Bruce Freeman Rail Trail Design Task Force Recommendations Report

March 21, 2017
Board of Selectmen Meeting

Recommendations: Alternative Routes

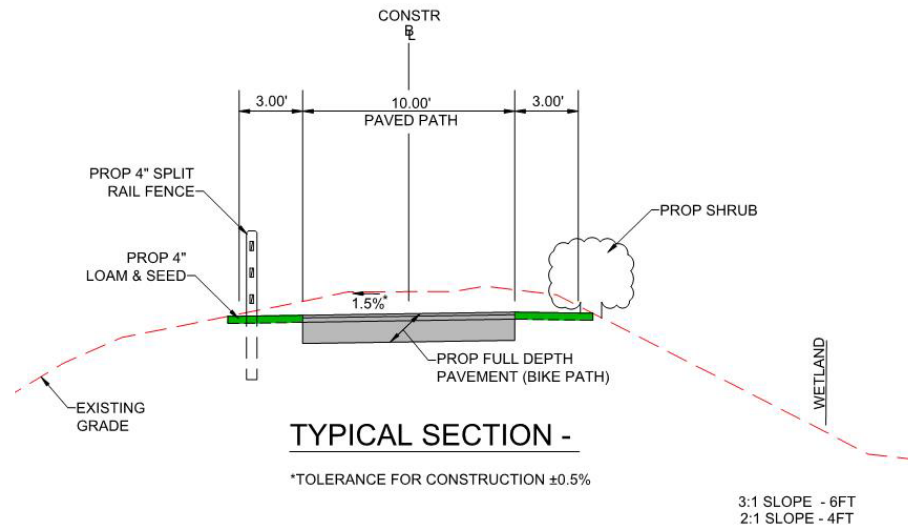
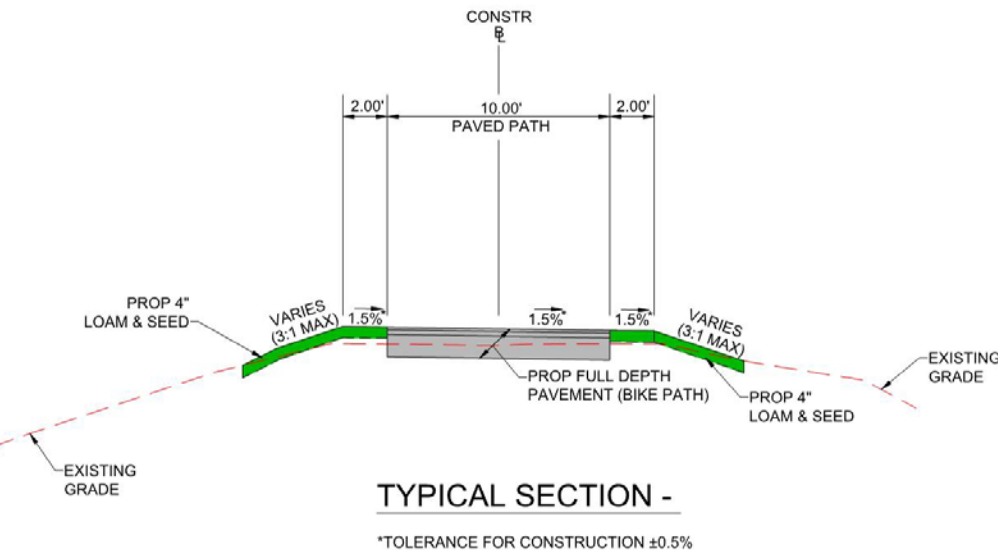
- Alternative Routes –None of the presented roadway alternative options are considered feasible
 - Infeasibility is based on limited right of way, lack of abutter support, cost, safety concerns at the roadway intersections and the numerous driveway intersections, and lack of desired trail user experience
- It is recommended that the Design Team continue to collaborate with the concerned businesses abutting the rail corridor to identify potentially more feasible alternatives

Challenge Areas (in pink)

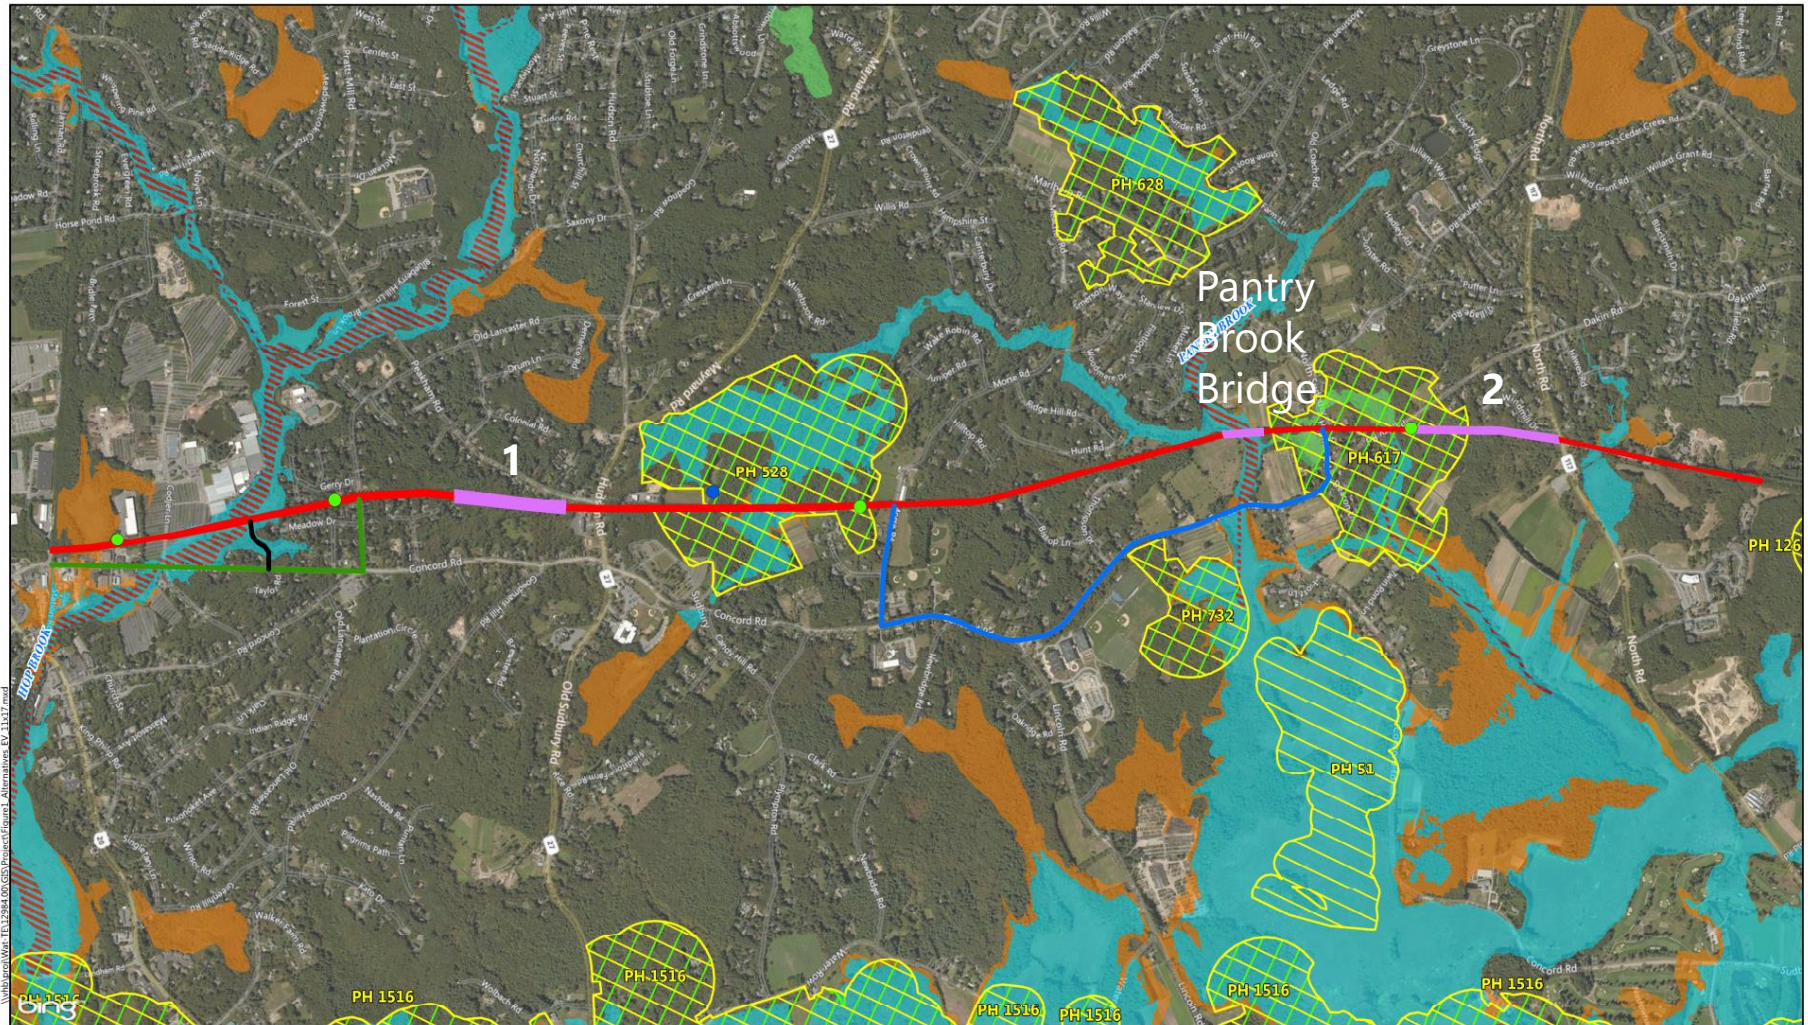
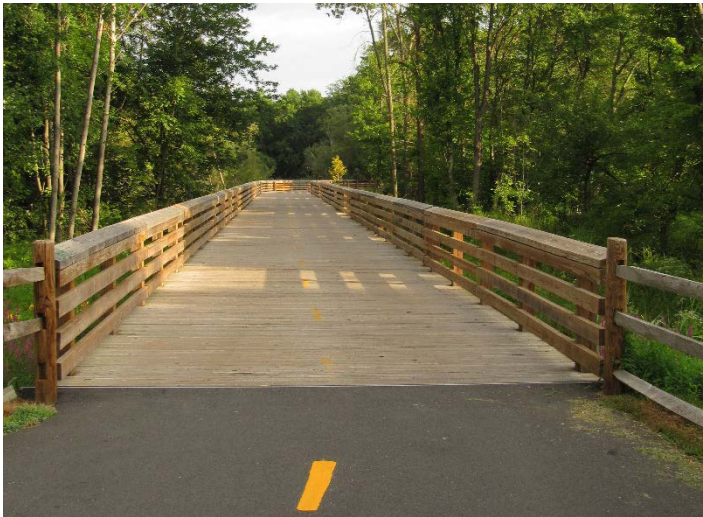
- Challenge area (#1) south of Hudson Road (650 ft): 14-foot elevated boardwalk
- Challenge area (#2) south of North Road (1200 ft): Reduced width and retaining walls. 10-foot paved path and 1-foot shoulders.
